## Global Change Notification (GCN)

Product Family

GCN Number

Current terminal

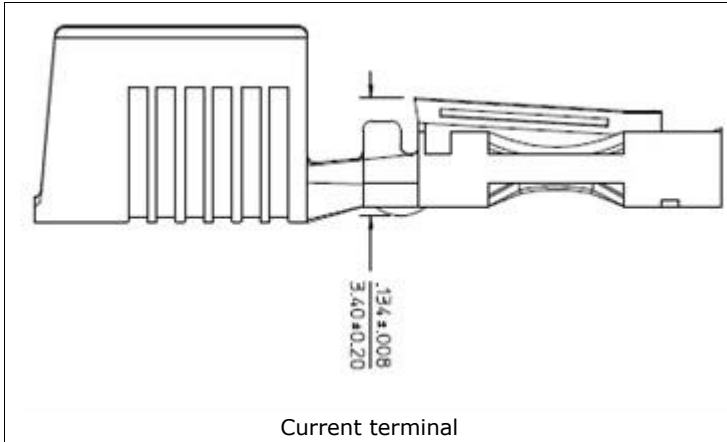
Change Description
